NOTICE OF DECISION

CLASS 3 SITE PLAN REVIEW AND CLASS 2 ADJUSTMENT CASE NO.: SPR-ADJ22-33

SUMMARY: An application for various site improvements associated with a change of use for Hillcrest Behavioral Health facility.

HILLCREST BEHAVIORAL HEALTH
2450 STRONG ROAD SE, SALEM, OR 97302

C2.00

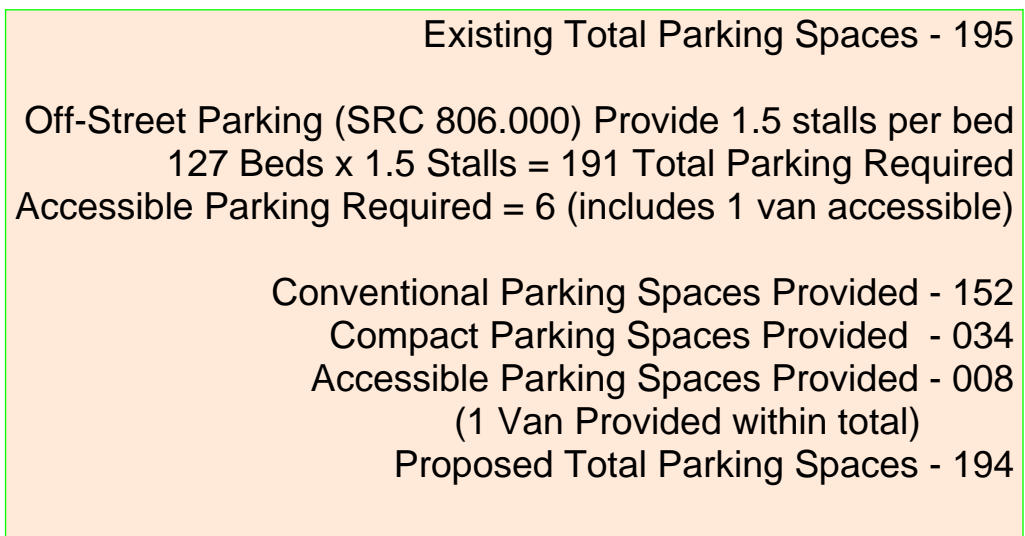
Finding: The applicant indicated that 127 beds would be provided for the subject behavioral facility, which yields an off-street parking requirement of 191 spaces ($127 \times 1.5 = 190.5$). The proposed site plan shows 194 off-street parking spaces, which meets the minimum standard.

Finding: Based on a minimum off-street parking requirement of 191 spaces, the maximum number of compact parking spaces allowed is 143 spaces ($191 \times .75 = 143.25$). The proposed development includes a total of 34 spaces, which meets the maximum standard.

Finding: The applicant's site plan indicates ADA improvements to small areas of the off-street parking area, which meet perimeter setbacks and landscaping as required by this standard. No other changes are proposed to perimeter setbacks or vehicle use areas elsewhere on the development site.

Finding: The development site includes existing nonconforming off-street parking areas, which are nonconforming to this standard. The applicant has requested an adjustment to eliminate the required interior parking lot landscaping for the existing vehicle use areas, as the parking lot improvements are for limited areas within the development to meet ADA requirements. The applicant has proposed to provide the interior landscape for those specific areas of improvements. Findings for the adjustment can be found in Section 8 of this report. Further conformance with landscaping standards will be reviewed at the time of building permit.

Condition 3: At the time of building permit review, the applicant shall provide bumper guards or wheel barriers for all new parking spaces abutting a pedestrian connection or required landscaping.

Condition 5: At the time of building permit review, the applicant shall provide a landscape plan that includes Type A landscaping for all four vehicle use areas where ADA parking is being provided. A summary table of the square footage, plant species, corresponding plant units, quantity and sizes shall be provided, which includes a minimum of 40 percent of the required number of plant units to be a combination of mature trees, shade trees, evergreen/conifer trees, or ornamental trees.

DATE 03/01/22	PROJECT NUMBER 212020
SHEET NUMBER	C3.00

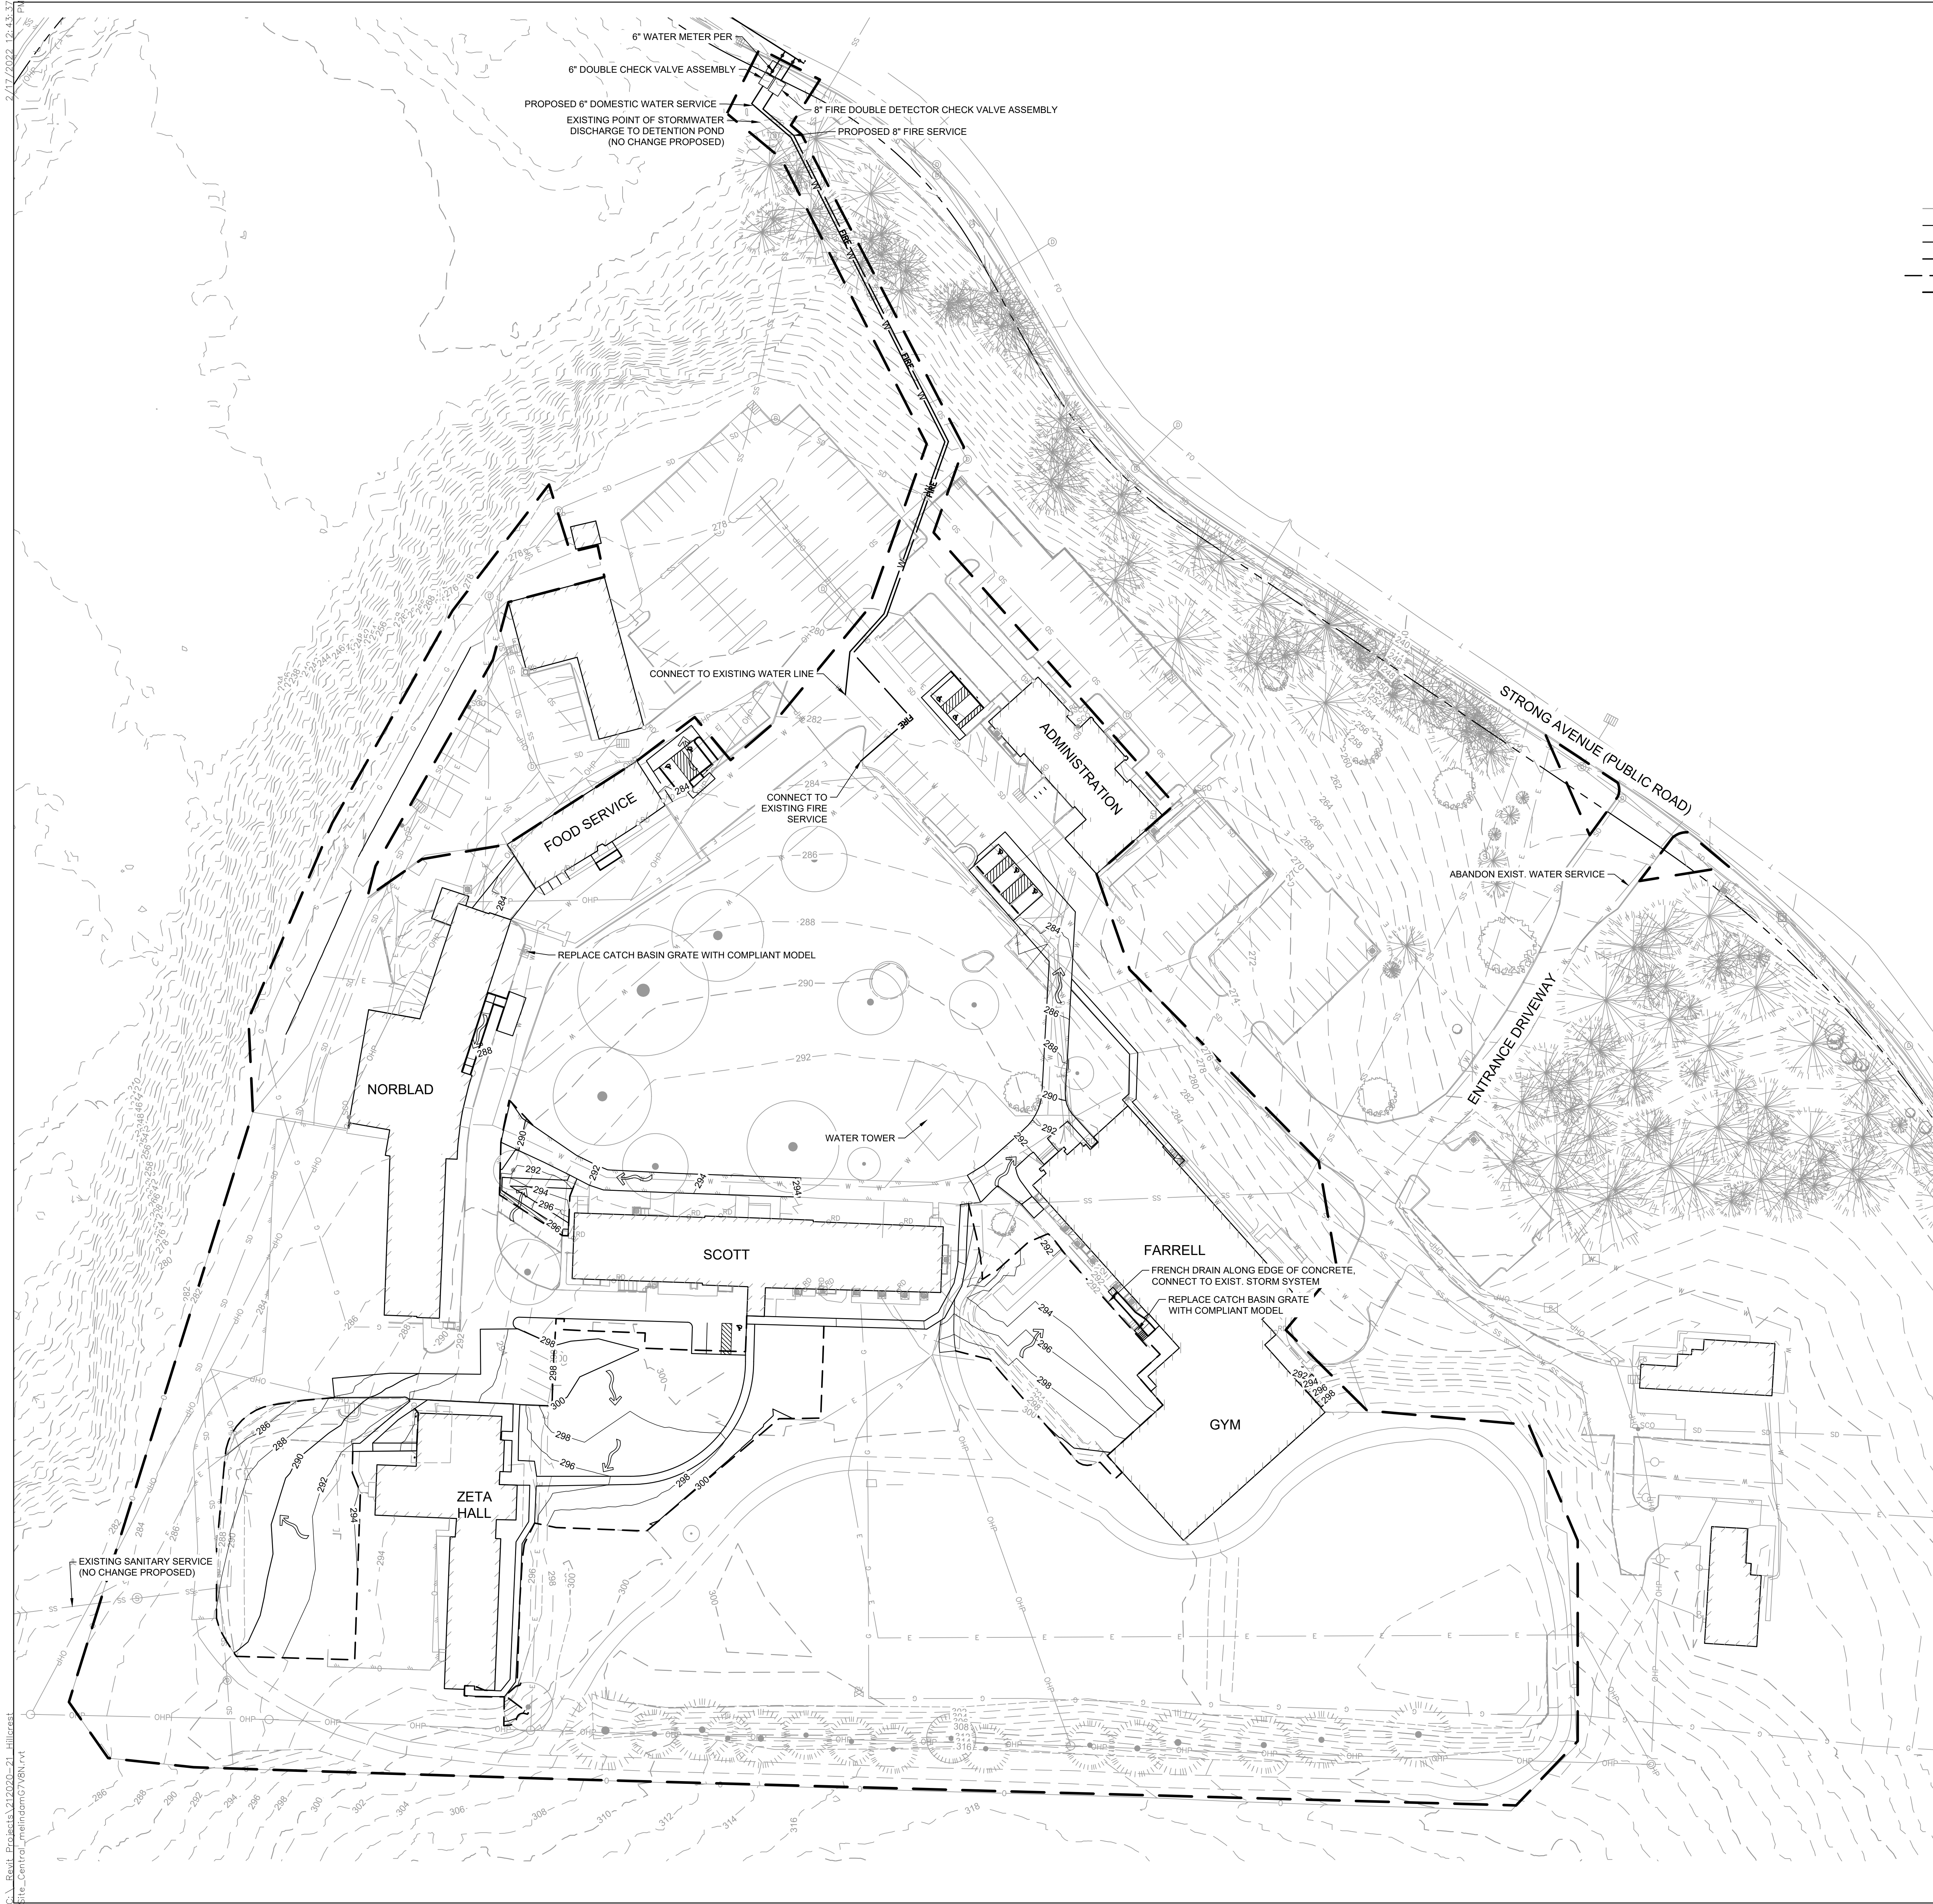
The existing development is served by a private well with an emergency connection to City water for fire protection only. The applicant's preliminary utility plan shows a new connection to City water in Strong Road SE pursuant to SRC 802.015. There is not an existing public water main in Strong Road SE to serve the development. City water is

The applicant shall be required to design and construct a storm drainage system at the time of development. The application shall provide an evaluation of the connection to the approved point of discharge for new areas of impervious surface per SRC 71.075.

- Condition 4:** Extend a minimum 12-inch public water main in Strong Road SE to the site from the intersection of Strong Road SE and Reed Road SE.
- Condition 5:** At the time of building permit review, the applicant shall provide a landscape plan that includes Type A landscaping for all four vehicle use areas where ADA parking is being provided. A summary table of the square footage, plant species, corresponding plant units, quantity and sizes shall be provided, which includes a minimum of 40 percent of the required number of plant units to be a combination of mature trees, shade trees, evergreen/conifer trees, or ornamental trees.

DATE 03/01/22	PROJECT NUMBER 212020
SHEET NUMBER	L1.00

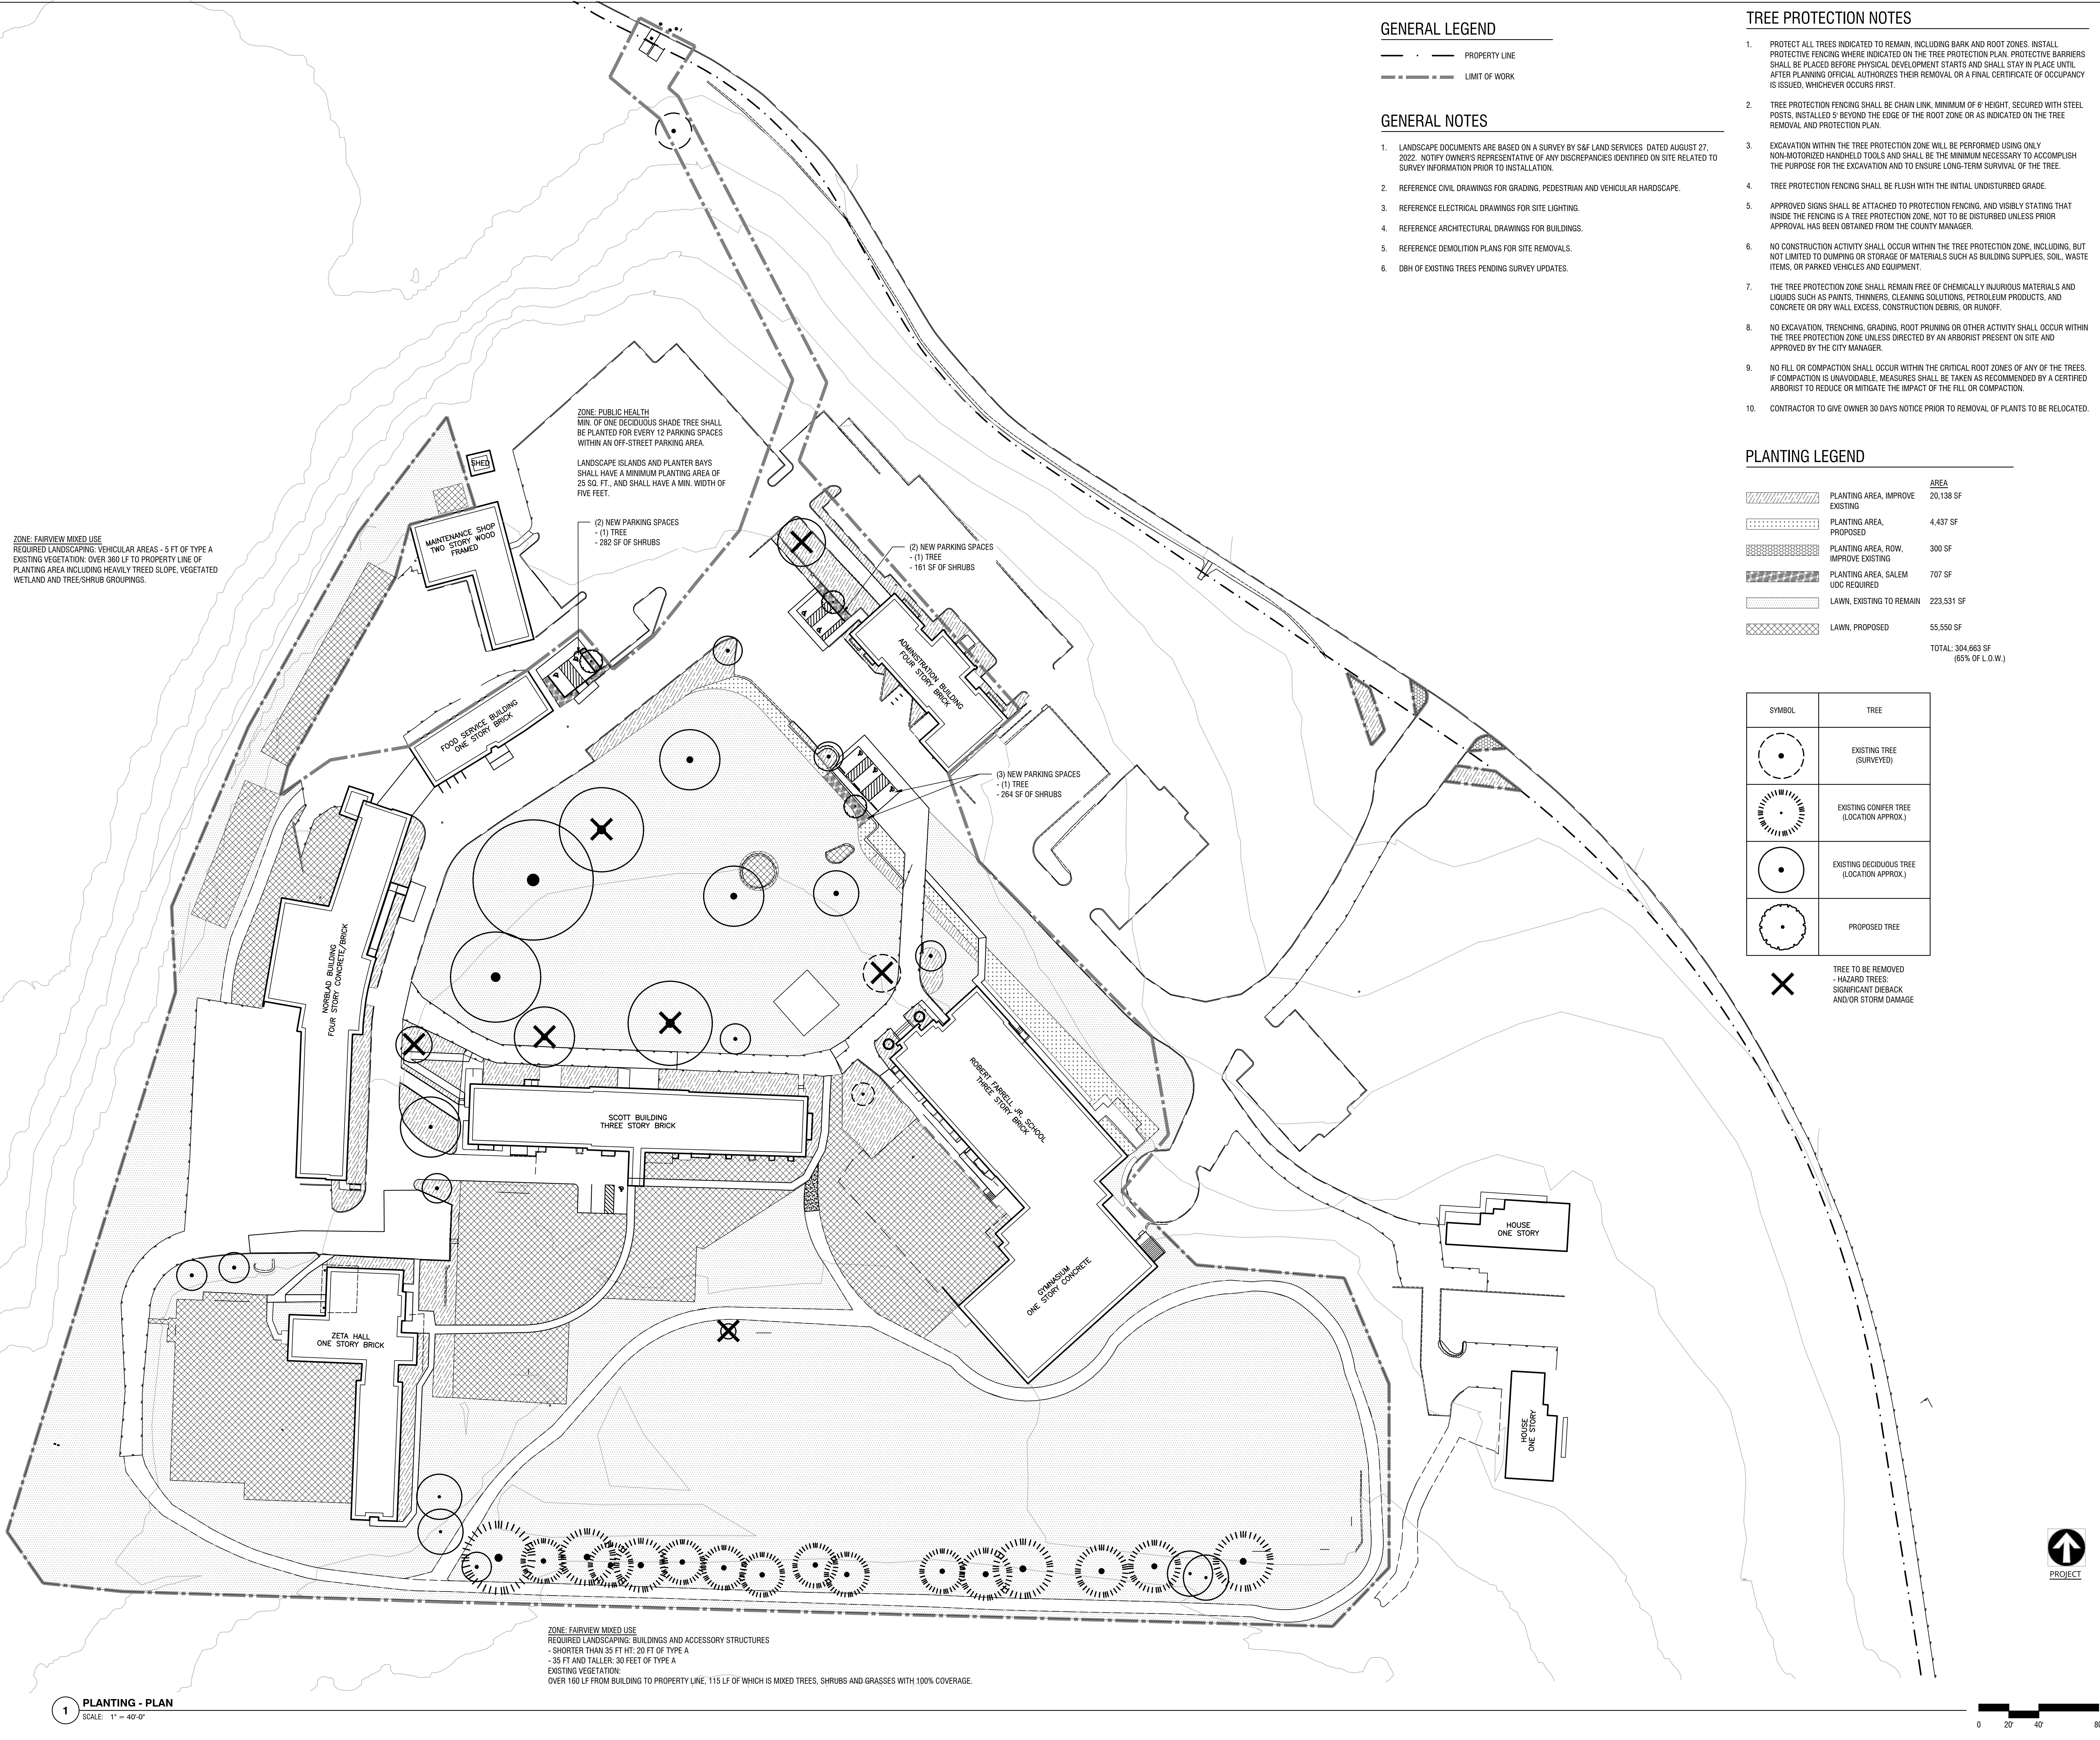
Interior landscaping shall be provided in amounts not less than those set forth in Table 806-5. The development site includes existing nonconforming off-street parking areas, which are nonconforming to this standard. The applicant has requested an adjustment to eliminate the required interior parking lot landscaping for the existing vehicle use areas, as the parking lot improvements are for limited areas within the development to meet ADA requirements. The applicant has proposed to provide the interior landscape for those specific areas of improvements which meets the intent of the standard. In addition, the applicant explains that the subject property is heavily screened with large landscape buffers over 100 feet on all sides, surrounding the property with landscaping that exceeds the minimum standards. Since a full landscape plan including all proposed plant units was not provided, the landscaping requirement is conditioned below.
